RE: Roll Tide Properties Corp. / Deer Meadows Subdivision Appeal 21-061 AP
(Appeal of File No. 21-014 SUB/TREE)

This firm represents Roll Tide Properties Corp., the Applicant in the above-referenced file. This letter sets forth the Applicant's response to the Council Staff Report for the February 22, 2021 Council hearing, which recommends denial of the Applicant's appeal and by extension, denial of the Applicant's subdivision application. The Applicant's specific objections are set forth below. For the reasons below, the Council should grant the Applicant's appeal and reverse the Planning Commission's decision.

Please note that appended to this letter is a revised subdivision concept which demonstrates how all clear and objective criteria are satisfied, including a revision to ensure that all lots have at least 20 feet of frontage to a public right-of-way. **Exhibit 1**. ORS 197.522(3) provides as follows:

DEER MEADOWS

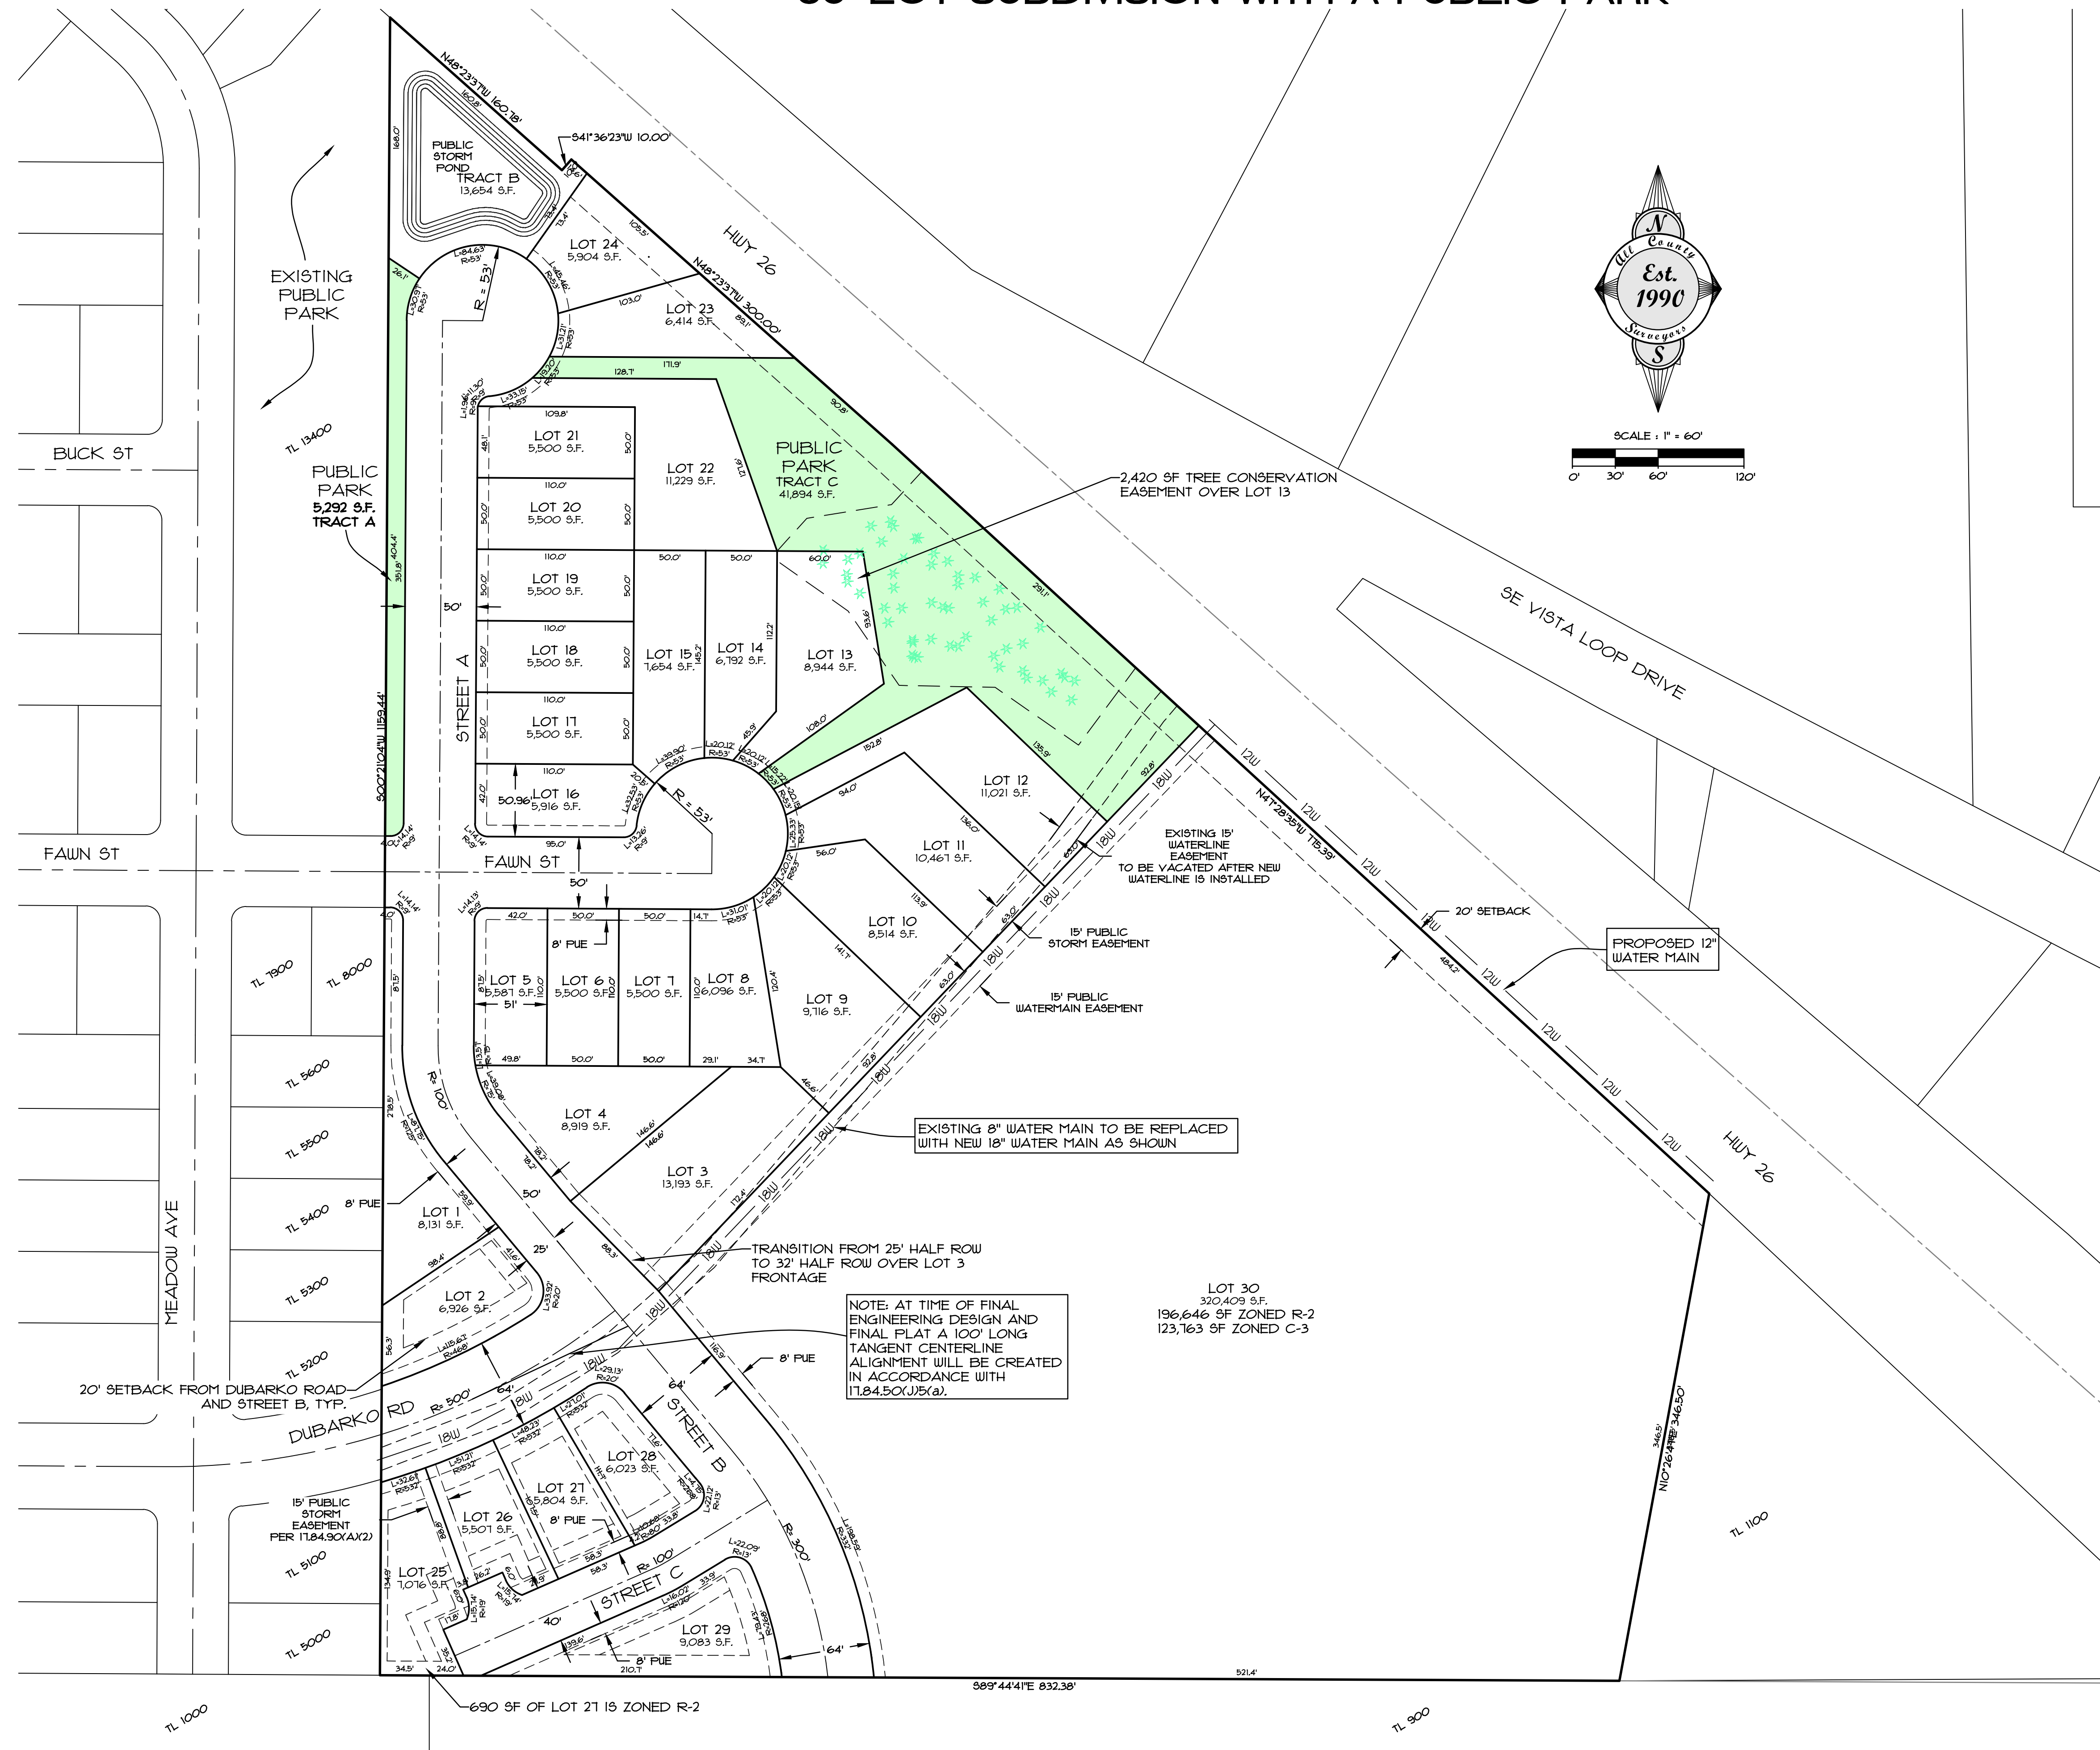
12) This subdivision proposal does not propose to dedicate 0.96 acres of parkland as required by Chapter 17.86. The additional .96 acres could expand Deer Pointe Park consistent with the Parks and Trails Master Plan that was adopted in 1997.

Regardless, **Exhibit 5** demonstrates how the Applicant could provide the minimum required park area. Pursuant to ORS 197.522(3), if the Council nonetheless concludes that it is not barred from requiring the park dedication, it can impose a condition of approval requiring a park area as shown on Exhibit 5 of this letter.

PARKLAND DEDICATION SHOWN AT 4/-1 ACRE. MINIMUM REQUIRED AT TIME OF FINAL PLAT TO BE 0.93 ACRES (40,511 SF). ADJUSTMENTS TO LOT LINES WILL BE MADE AT TIME OF FINAL PLAT TO PROVIDE 0.93 ACRES OR MORE.
